Center of the American Experiment

Comments on

New Source Performance Standards for Greenhouse Gas Emissions from New, Modified, and Reconstructed Fossil Fuel-Fired Electric Generating Units; Emission Guidelines for Greenhouse Gas Emissions from Existing Fossil Fuel-Fired Electric Generating Units; and Repeal of the Affordable Clean Energy Rule (Docket ID No. EPA-HQ-OAR-2023-0072; FRL-8536-02-OAR).

August 8, 2023

Figure 1. EPA's modeled resource portfolio in MISO undergoes significant changes in each of the model years, with installed capacity increasing 2.56 times in 2055 compared to 2021.

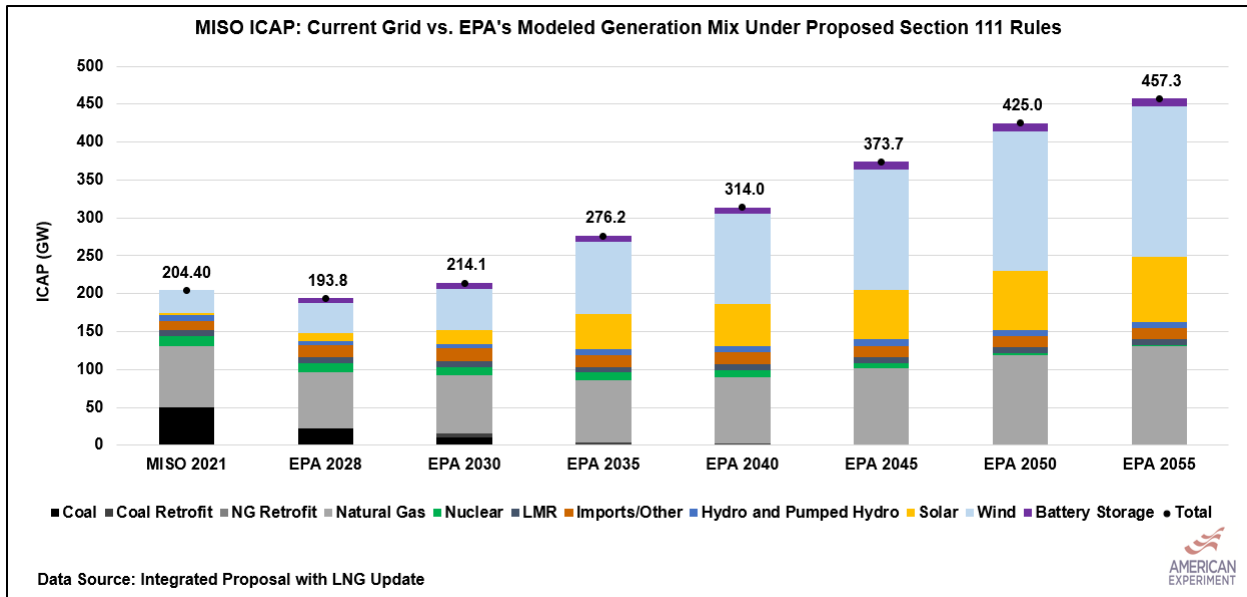
Between 2021 and 2055, EPA projects the installed capacity on the MISO system will grow from 204 GW of installed capacity to 457.3 GW despite the retirement or retrofitting of the entire coal fleet by 2035. As a result, EPA is assuming the installed capacity of the MISO grid will grow by a factor of 2.5 over the next 30 years, with most of this new installed capacity consisting of onshore wind, solar, combustion turbine (CT) natural gas, and battery storage.

Although EPA is modeling a 2.5-fold increase in the amount of installed capacity on the MISO grid, it is also projecting that there will be less dispatchable capacity online in 2055 than in 2021 as a percentage of peak demand. This occurs because dispatchable capacity, defined in this analysis as any resource other than wind or solar, on EPA's modeled MISO system, grows by only 2.1 GW despite EPA's assumption that peak load in MISO will increase by 42 percent, rising from 124.21 GW in 2021 to 177.6 GW in 2055.

The gap between the amount of dispatchable capacity and the projected peak load and target reserve margin in EPA's modeled MISO grid in 2055 seriously undermines EPA's assertion that the proposed Section 111 rules maintain Resource Adequacy (RA) and reliability on the MISO system.

Figure 3. EPA’s modeled MISO grid under the Integrated Proposal with LNG Update relies on intermittent resources such as wind and solar to perform at their capacity accreditation to keep the lights on and meet reserve margin targets.

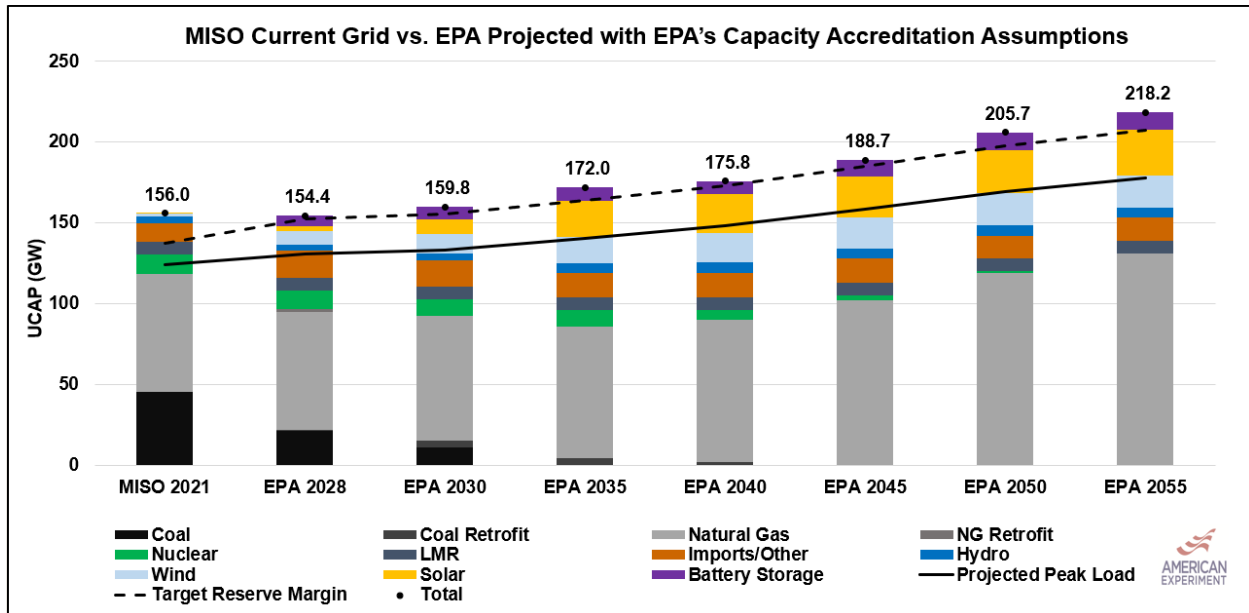
Despite these generous assumptions, EPA’s modeled MISO grid is relying on intermittent wind and solar to meet its target reserve margin in 2028, and it relies on wind, solar, and battery storage to meet its projected peak demand for every year from 2030 and beyond (See Figure 3).

EPA’s reliance on wind and solar to meet the projected peak load and target reserve margin means that these resources must be at least operating at their accredited capacity to keep the lights on during periods of high demand. If they underperform their accreditation, which happens frequently, then EPA’s modeled grid cannot maintain reliability, resulting in capacity shortfalls.

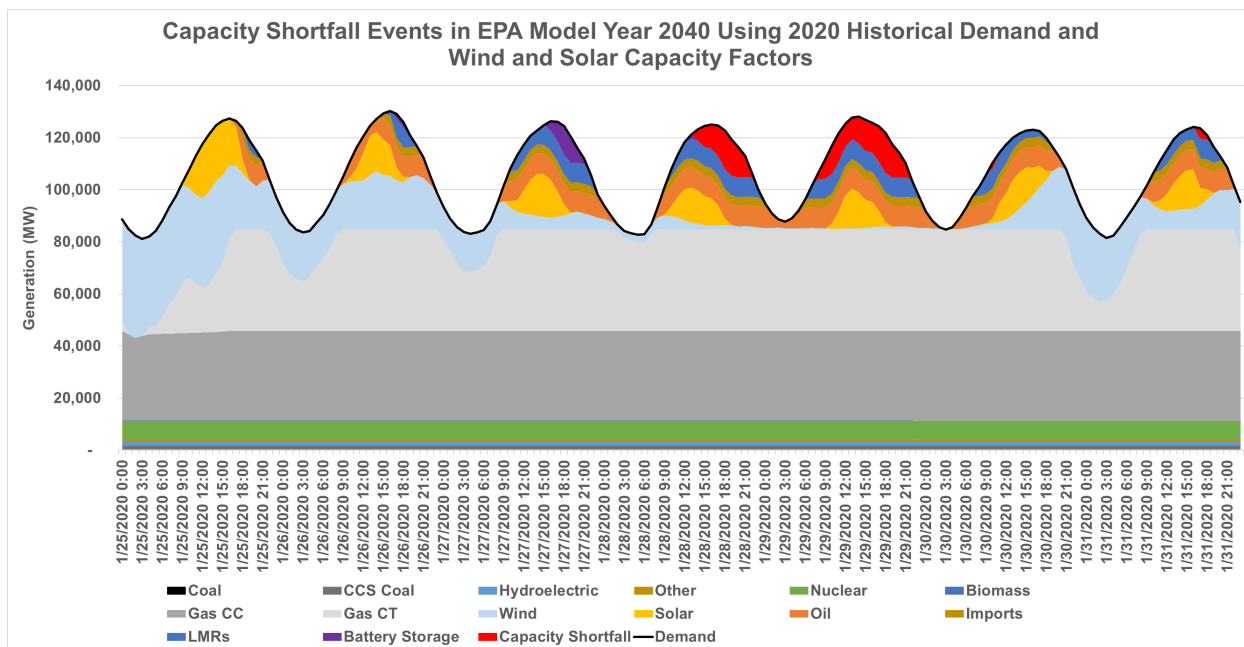
A total of 607 hours of capacity shortfalls were observed in the modeled years (2028, 2030, 2035, 2040, 2045, 2050, and 2055) across all HCYS, with 274 hours of blackouts observed using the 2019 HCY and 183 hours in the 2021 HCY. The longest capacity shortfall would last 15 hours, occurring in a theoretical week in January 2040 after the regulations have been implemented if the grid experienced the same hourly electricity demand and wind and solar generation as it did in 2020 (See Figure 4).

These blackouts would occur because MISO experienced “wind drought” during this period where wind capacity factors were below 10 percent for 80 consecutive hours. For 42 consecutive hours, wind generation was below 1.5 percent, essentially rendering the entirety of the wind fleet unavailing.

Additionally, EPA’s modeled MISO grid in 2040 does not have enough dispatchable natural gas capacity to meet all of MISO's electricity demand. As a result, the region would be dependent upon generation from wind and solar resources, imports from neighboring regions, and battery storage facilities to meet demand. Unfortunately, due to the long duration of the wind drought, the wind resources in MISO would not be able to recharge the batteries needed to maintain reliability, resulting in 15 consecutive hours of blackouts in January of the 2040 model year.

Figure 5. The blackouts occurring in January of 2040 using the 2021 HCY would be massive, constituting 26 GW, which is 19.5 percent of the electricity demand on the system at the time.

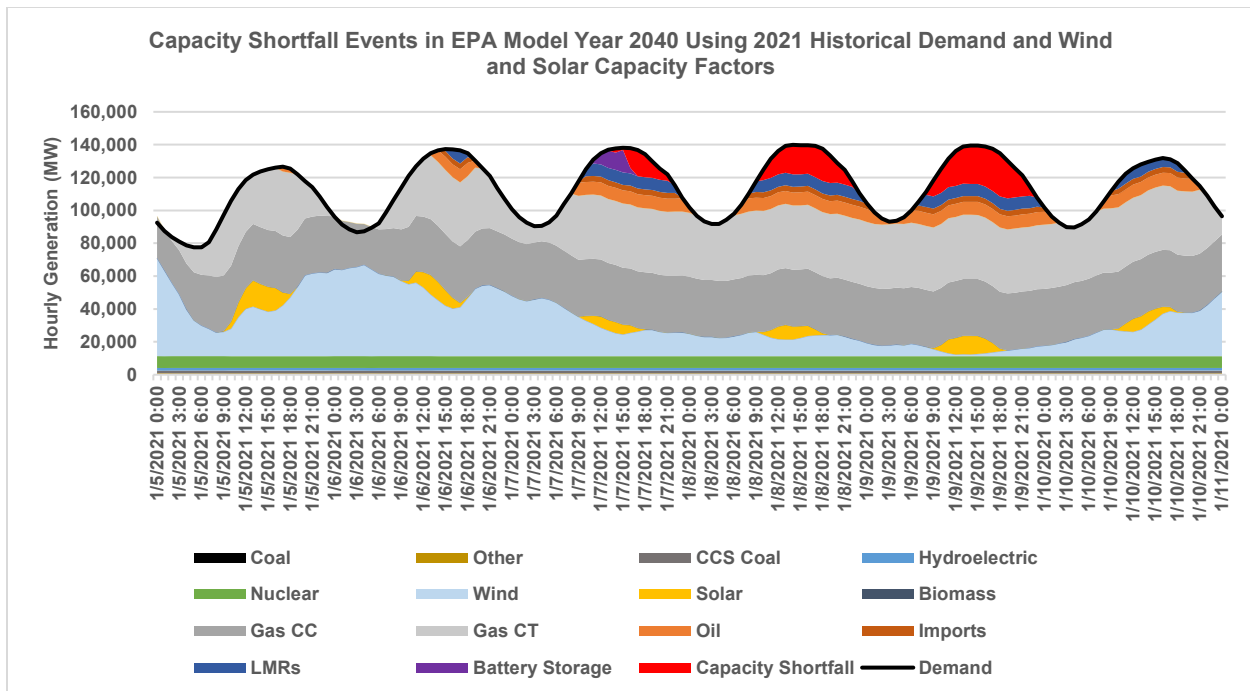
Many of the observed blackouts are significant. For example, our analysis found EPA’s modeled grid would result in a massive blackout totaling over 26,000 MW (26 GW) in capacity shortfalls in the 2040 EPA model year using the 2021 HCY (See Figure 5).

For context, this represents 19.5 percent of the electricity demand on the MISO system at the time of the capacity shortfall, meaning one in five homes would be subjected to rolling power outages.

Such large capacity shortfalls would be difficult to manage, resulting in undue hardship on grid operators and the customers they serve.

Figure 6. Estimated firm capacity using EPA’s accreditation values for wind, solar, storage (100%), and thermal resources (100%). EPA assumes a 16.8 percent reserve margin. Red indicates intermittent generation is necessary to meet Target Reserve Margins.

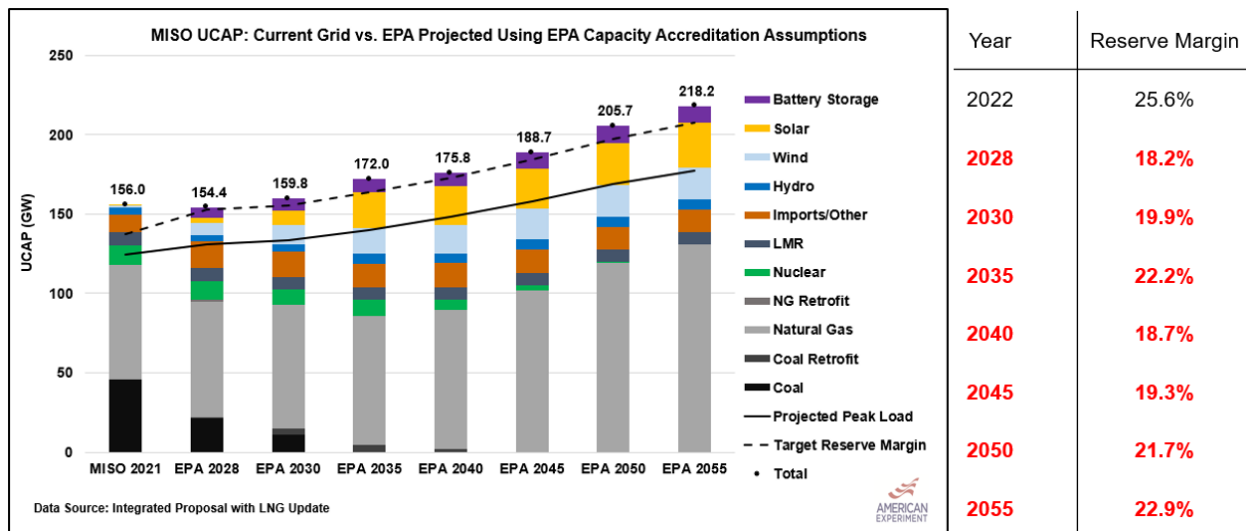
Figure 6 shows EPA’s projected peak demand and reserve margin on its modeled MISO grid are “satisfied” using intermittent wind and solar resources, with battery storage intended to store the electricity generated by these generators for later use. EPA’s modeled MISO grid relies on these resources to meet the target reserve margin in every model year (2028-2055) and to meet the projected peak demand in 2030 and beyond.

EPA’s reliance on the use of intermittent generators to ensure RA and reliability greatly increases the importance of having accurate accreditation values (UCAP values) for these intermittent generators. Unfortunately, EPA’s UCAP figures for wind and solar are too high, leading EPA to achieve its RA targets on paper, but not when this modeled MISO grid is subjected to an hourly reliability stress test.

Figure 7. EPA’s IPM assumes constant UCAP values for existing wind and solar resources and declining values for new wind and solar resources. Thermal accreditation is held constant at 100 percent.

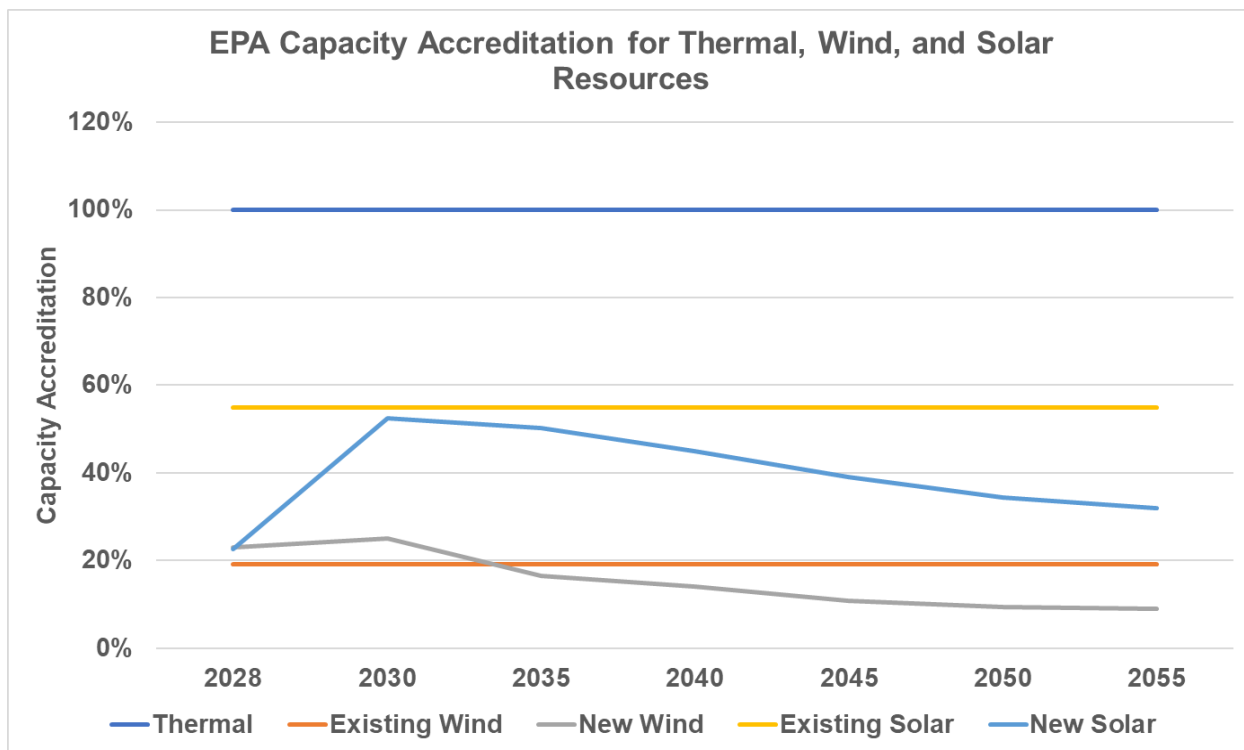
Existing wind and solar facilities are given capacity values of 19 percent and 55 percent. These values are large relative to new wind and solar capacity entering service (with capacity values ranging from 9 to 25 percent for new wind and 32 to 52 percent for new solar) during the model run, and these UCAP values are held constant throughout the model run (See Figure 7).

EPA correctly assumes a declining UCAP for new wind and solar resources because the incremental value of each MW of installed intermittent capacity falls as more of these generators are added to the grid. However, EPA’s assumption that existing generators will have a constant capacity value that is different from new generators of the same type is problematic because intermittent wind and solar resources, especially solar power, tend to be highly correlated regardless of when the asset was placed into service. Therefore, one capacity value for wind and one capacity value for solar, both new and existing, would be a more appropriate way to assess their contributions to resource adequacy.

Furthermore, EPA’s UCAP values for new intermittent capacity are still too high, as is EPA’s assumption that thermal resources will get a 100 percent capacity credit.

Figure 8. From June 22, 2023, to July 5, 2023, wind capacity factors on the MISO system routinely underperformed EPA’s capacity accreditation. Because wind is a non-dispatchable resource, grid planners must plan to provide electricity during periods of its lowest output.

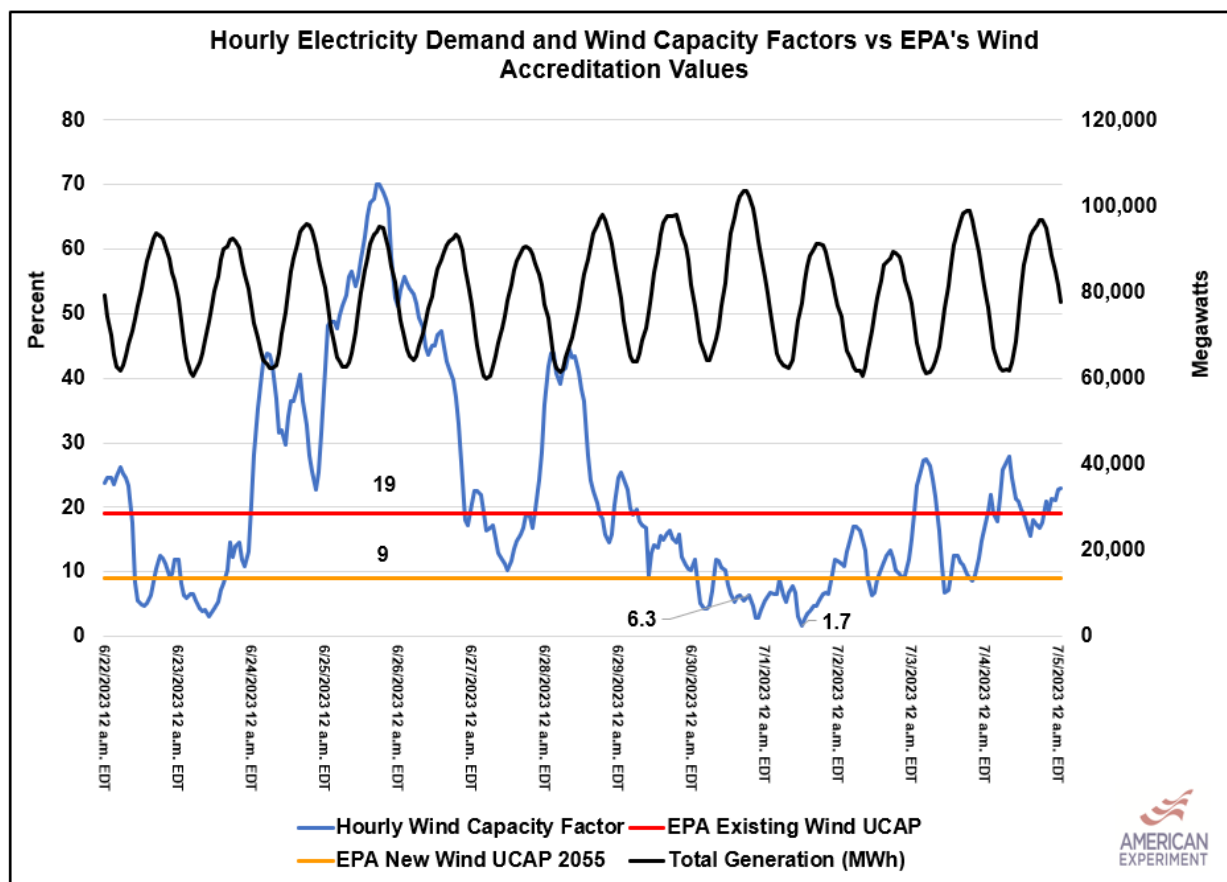
Figure 8 demonstrates how EPA’s UCAP accreditation for wind would leave its modeled MISO grid short of energy. The figure shows hourly electricity demand in black and the hourly capacity factor of the entire MISO wind fleet in blue. The red line indicates EPA’s UCAP value for existing wind, and the orange line indicates its UCAP value in 2055.

Despite the lower accreditation in 2055, wind is still underperforming its UCAP during the peak demand period by approximately 30 percent. This underperformance is manageable on a system where there is adequate dispatchable capacity to meet demand, but it becomes increasingly unmanageable as grids become more reliant on intermittent wind and solar resources to meet projected peak demand and target reserve margins. As a result, grid planners of the future will need to plan to provide electricity during the periods of lowest wind and solar output. Doing so

will require more realistic capacity accreditation methods for all resources, especially wind and solar.

Figure 10. EPA’s modeled MISO grid does not maintain resource adequacy using real-world thermal resource accreditation and HCD values for wind and solar. This explains why EPA’s modeled grid experiences rolling blackouts in most modeled years and HCYs.

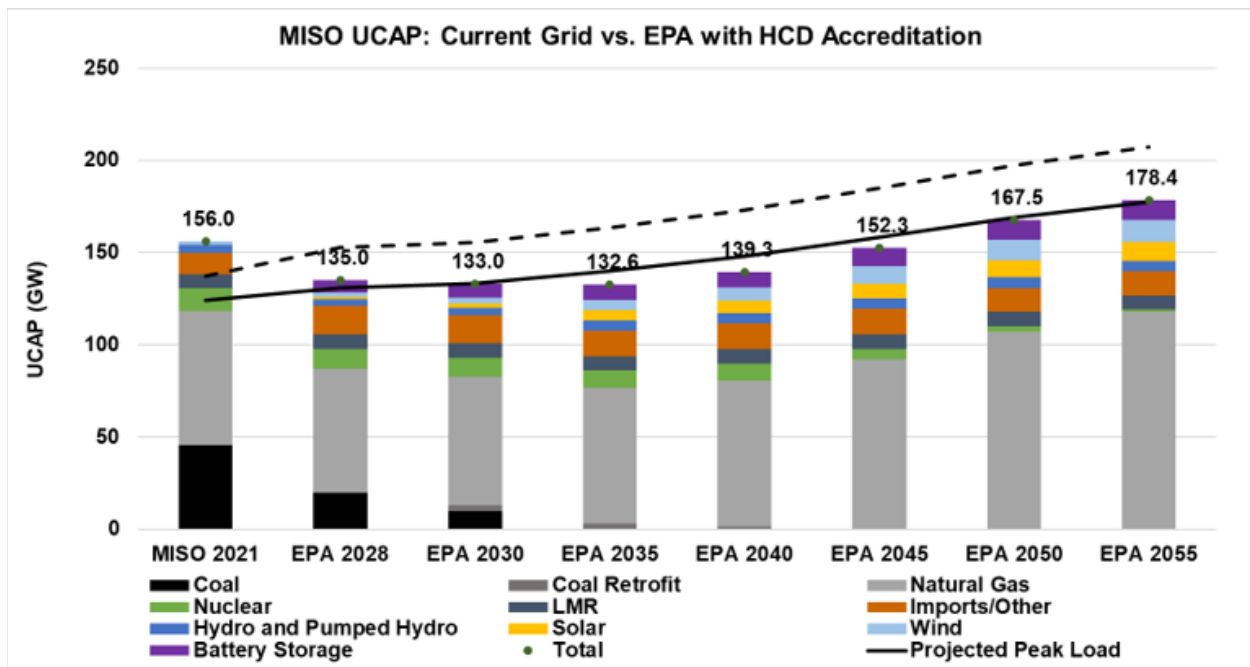
Using HCD values and real-world accreditation for thermal resources (95 percent for nuclear and 90 percent for other thermal generators compared to 100 percent used by EPA across the board, an accreditation seen in no RTO), the deficit becomes even worse (See Figure 10).

As you can see, using HCD values and real-world thermal accreditation values, EPA’s modeled grid falls short of meeting peak demand in 2035, 2040, and 2045, and in no modeled year does it meet its targeted reserve margin.

Figure 12. The MISO grid will require 146 GW of additional capacity to meet EPA’s emissions targets in MISO while maintaining grid reliability, a 32 percent increase relative to EPA’s assumptions in the Integrated Proposal with LNG Update.

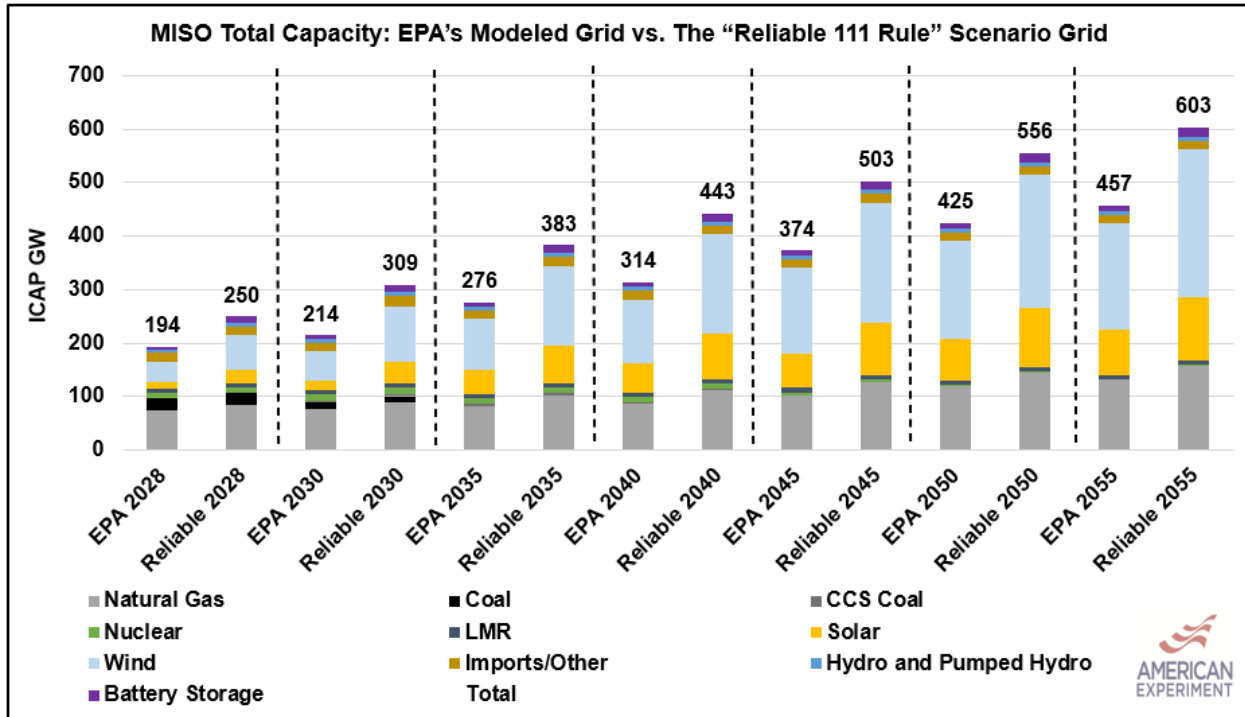
Our modeling concluded that avoiding capacity shortfalls on the MISO system under the proposed Section 111 rules in our “Reliable 111 rule” scenario would require an additional capacity buildout of 146 GW of capacity, representing a 32 percent increase relative to EPA’s Integrated Proposal with LNG Update (See Figure 12).

Figure 15. Although the Reliable 111 Scenario would save an additional \$30 billion in fuel savings and additional variable costs, these savings are far outweighed by the massive increases in capital spending and utility profits.

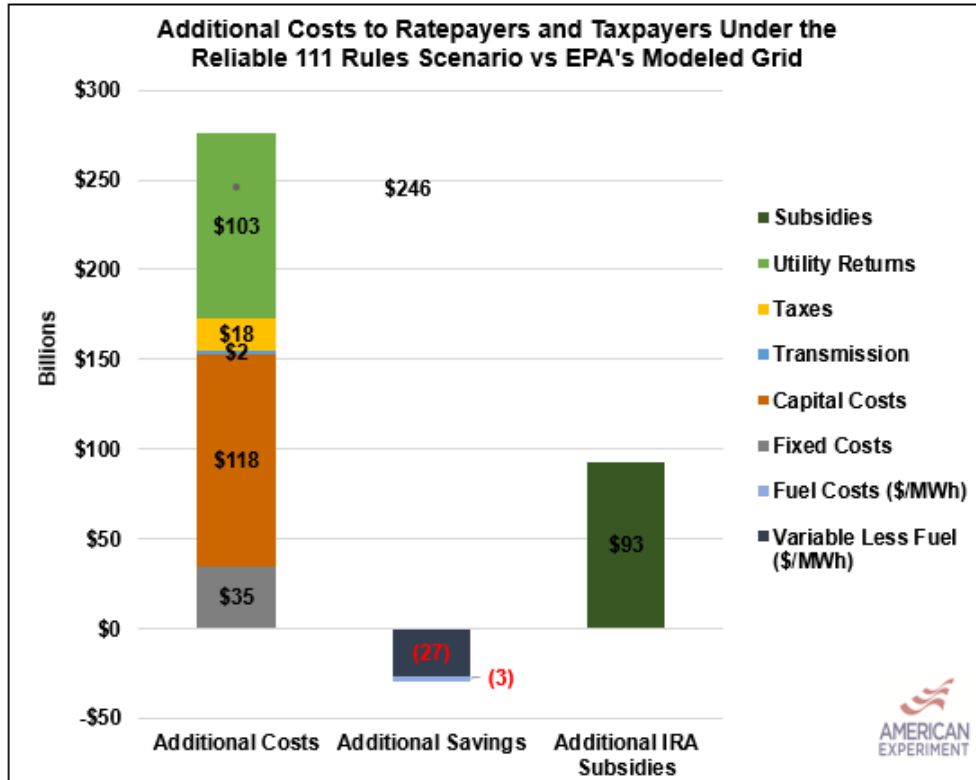
Our modeling determined the true cost of the proposed Section 111 rules to ratepayers would be \$246 billion in additional costs in the MISO region compared to the cost of EPA’s modeled grid in the Integrated Proposal with LNG Update (See Figure 15).

The Reliable 111 rule scenario saves \$30 billion, compared to the Integrated Proposal with LNG Update, in fuel costs and variable operations and maintenance costs. However, these savings are far outweighed by the additional fixed costs (\$35 billion), capital costs (\$118 billion), transmission costs (\$2 billion), additional taxes (\$18 billion), and utility profits (\$103 billion). These incremental costs mean reliably meeting EPA’s emissions targets under the proposed rules will cost an additional \$246 billion to ratepayers and an additional \$92.9 billion to taxpayers.

An additional compliance cost of \$246 billion equates to \$7.7 billion per year in incremental compliance costs for ratepayers, which exceeds EPA’s estimated net benefits for the rules of \$5.9 billion per year *for the entire country in just one RTO*. It is important to note that this figure does not include the additional \$93 billion in IRA subsidies that would be paid by taxpayers in the Reliable 111 rule scenario as more capacity is added to meet electricity demand and meet EPA’s emissions targets.
